Subject: Request for Data Gap Work Plan; for Fuel Leak Case No. RO0000342; (Global ID # T0600102076); Chevron #9-4800, 1700 Castro Street, Oakland, CA 94612

Alameda County Environmental Health (ACEH) staff has reviewed the case file including the *Conceptual Site Model and Closure Request*, dated April 11, 2014, and the *Second Semi-Annual 2013 Groundwater Monitoring and Sampling Report*, dated April 14, 2014. Both reports were prepared and submitted on your behalf by Conestoga-Rovers & Associates (CRA).

Therefore, at this juncture ACEH requests that you prepare a Revised Data Gap Investigation Work Plan that is supported by a focused Site Conceptual Model (SCM) to address the Technical Comments provided below.

Figure 2

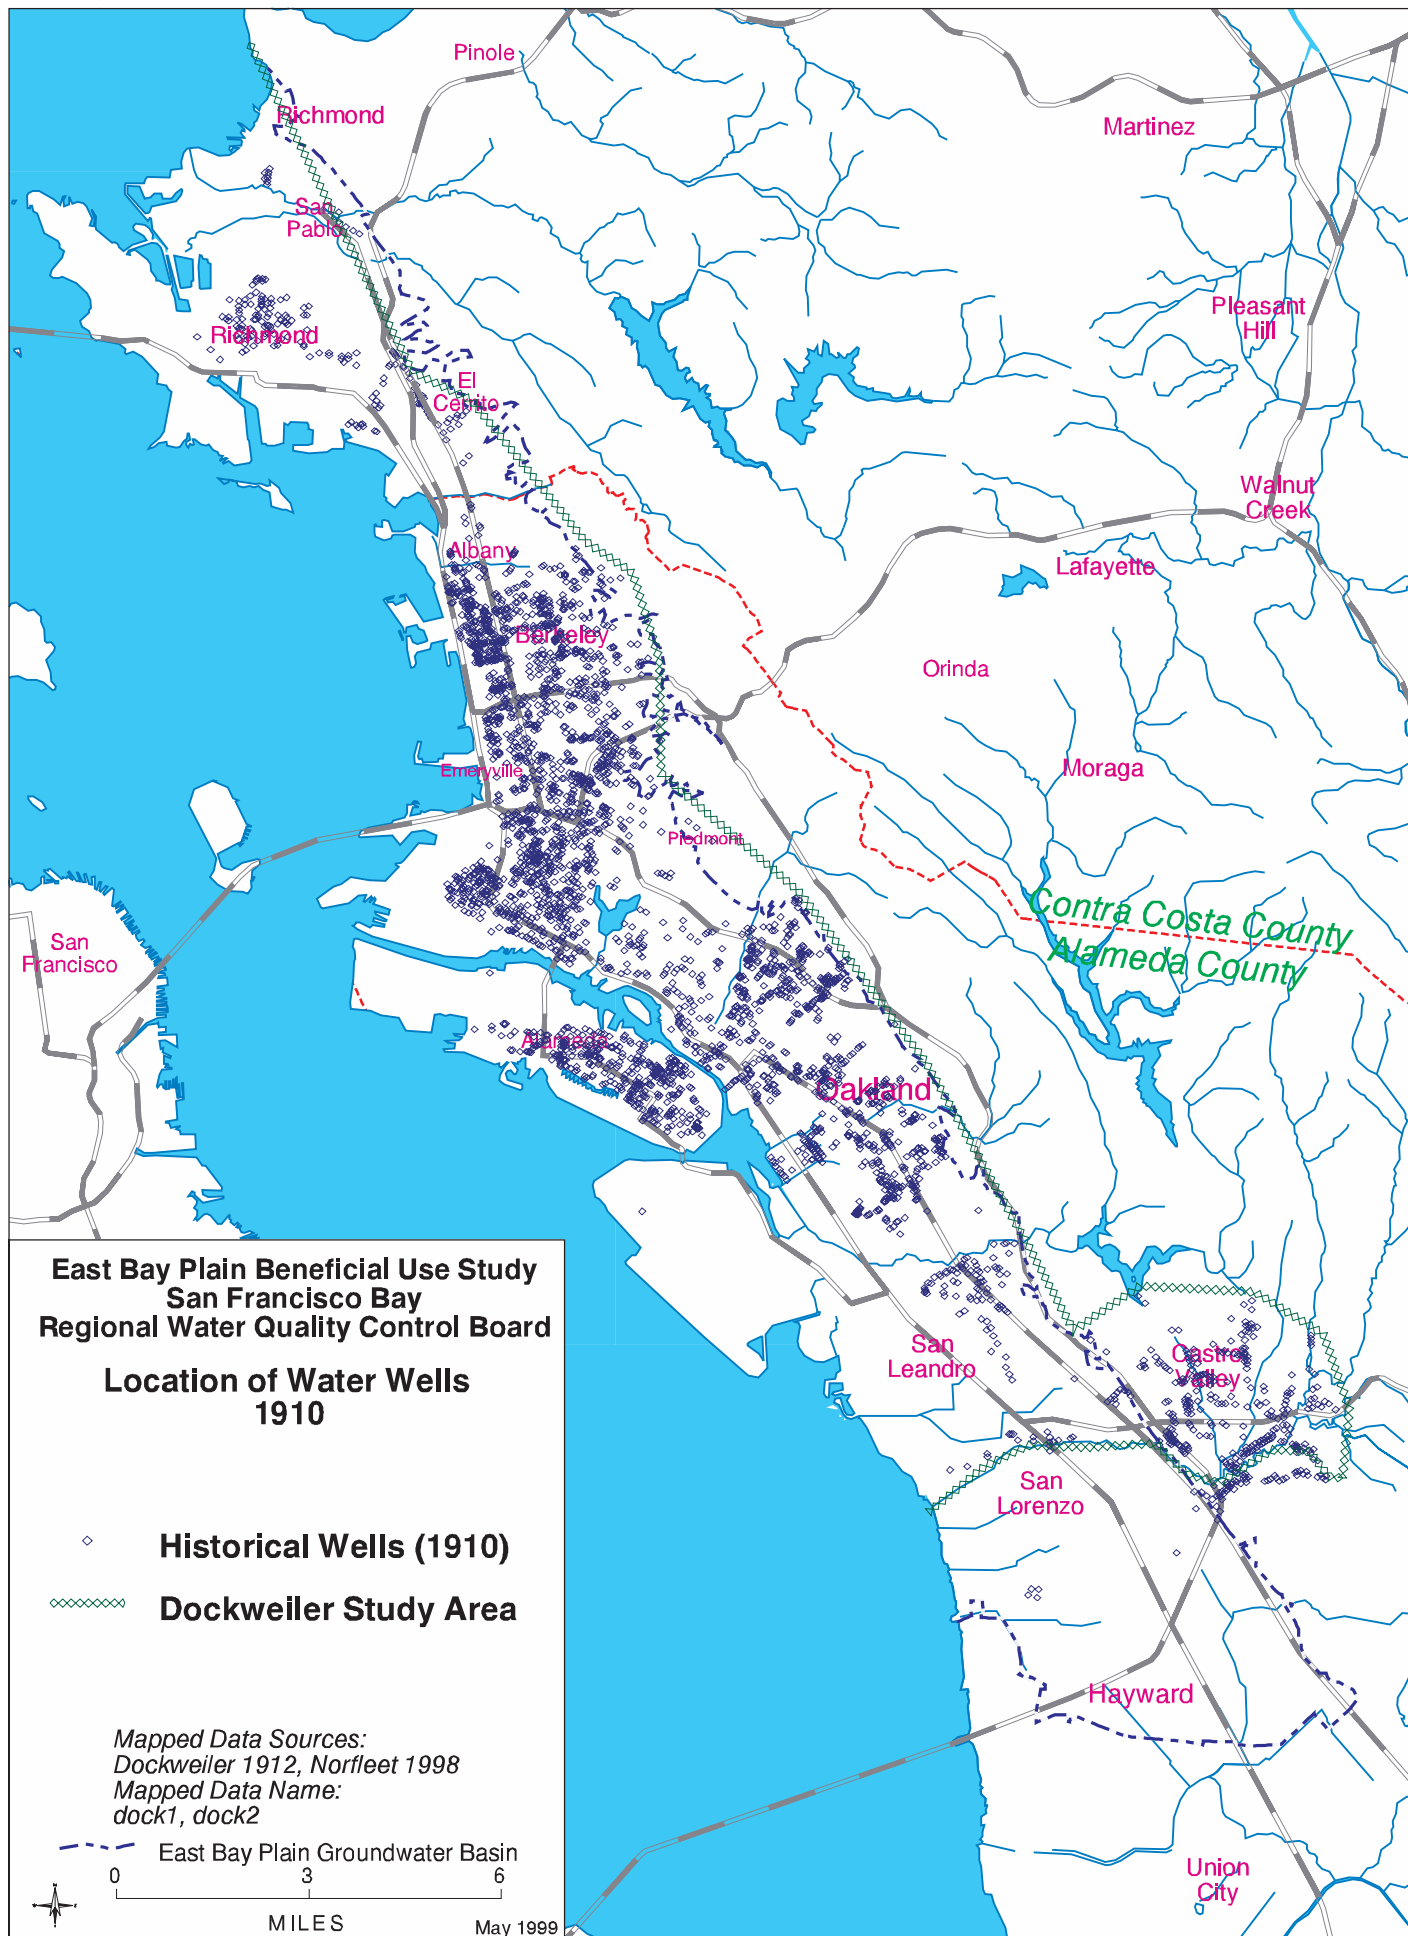
At the request of ACEH (directive letter dated August 15, 2013) the referenced SCM conducted a well survey. The well survey did not find water supply wells within 2,200 feet of the site. The closest well appears to be crossgradient, while the closest downgradient well appears to be at an approximate distance of 5,300 feet. However, review of Figure 5 from the *East Bay Plain Groundwater Basin Beneficial Use Evaluation Report, Alameda and Contra Costa Counties, CA*, San Francisco Regional Water Quality Control Board, dated June 1999, indicates that west Oakland has an exceptionally high incidence of early, apparently unregistered, water supply wells (see copy attached).

Because of the conflict in vicinity well data, it appears appropriate to conduct a door to door neighborhood well survey within the area of the potential maximum plume extent, to determine that older residential wells are not in use, and are not likely to be converted to use in a disadvantaged neighborhood, especially as water supplies decline in a drought year. Please note that the drought may be the reason for the recent decline in groundwater elevation and MTBE concentrations at the site, and that these conditions may continue for a period of time.
